QUALITY ASSURANCE -- NON-CONFORMANCE REPORT

Report No: NCR-000371

Reference Description: Longitudinal Diaphragm & Deck Plate

Job Name: SAS Superstructure

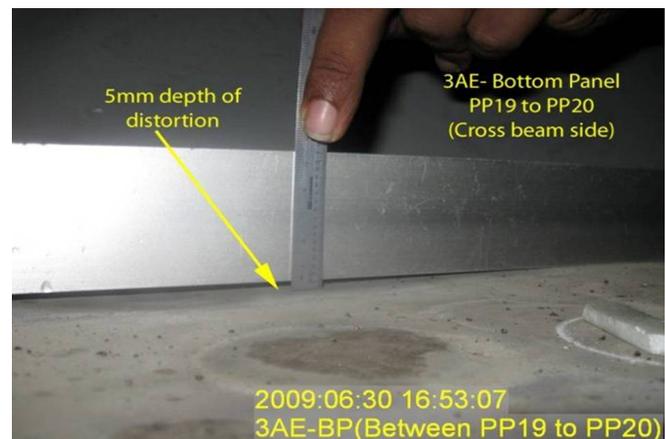
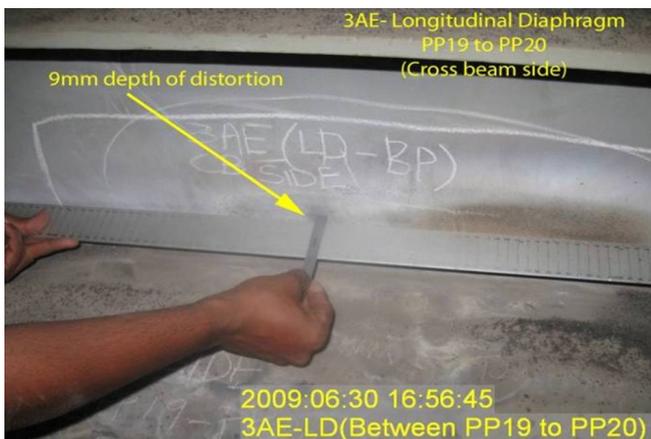
During in process visual inspection of the OBG Trial Assembly of Segment 3AE, Caltrans Quality Assurance (QA) Inspector discovered isolated distortion damage at Longitudinal Diaphragm and Bottom Plate between Panel Point 19 and 20 (Cross Beam Side). The distortion damage appears as a viable bulge in the Diaphragm and Bottom Plate at a location where an external support was positioned. The bulge appears to be related to heat straightening repairs. The heat straightening was performed without submitting a Heat Straightening Request to the Engineer. See the below photos for further information.

AWS D1.5 2002, Section 3.7.3: "Members distorted by welding shall be straightened by mechanical means or by carefully supervised application of a limited amount of localized heat as approved by the Engineer."

The proposed resolution is acceptable. The welds in question have been accepted by VT and MT as shown in the attached documents. The Department concurs that Non-Conformance ZPMC-0345 is closed.

With this letter of response, ZPMC requests closure for Caltrans **NCR-000371 (ZPMC-345)**. We agree what are submitted the FCN for the engineer approval that change one part of the LD in the middle to replace the distorted position, and also perform the round CJP weld per the WPS and drawing require, right now we provide the documentation to prove that the repair have been conducted and the weld were acceptable by NDT and visual inspection, by the way remind here that the corresponding item in the punchlist have been closed out by caltrans and ABF.
